**Standardization of technical and safety requirements in inland navigation:
Signs and Signals on Inland Waterways (SIGNI) (Resolution No. 22, revised)**

Amendment proposal to Signs and Signals on Inland Waterways (SIGNI) (Resolution No. 22, revised)

Note by the secretariat

(fig. 23)

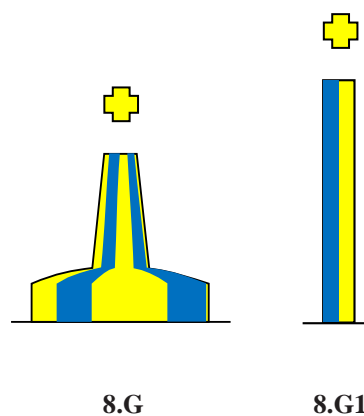
7. Add a new paragraph 2.4.6

“2.4.6 Marking of new dangers

2.4.6.1 Definition of New Dangers

The term “New Danger” is used to describe newly discovered hazards not yet shown in nautical documents. New Dangers include naturally occurring obstructions such as sandbanks or rocks or man-made dangers such as wrecks.

2.4.6.2 Description of New Dangers

New Dangers marks

Colour: Blue and yellow vertical stripes in equal number dimensions (minimum 4 stripes and maximum 8)

Form: pillar or spar

Topmark (if any): vertical or perpendicular yellow cross

Light (when fitted):

Colour: yellow/blue alternating

Rhythm: one second of blue light and one second of yellow light with 0.5 seconds of darkness between.
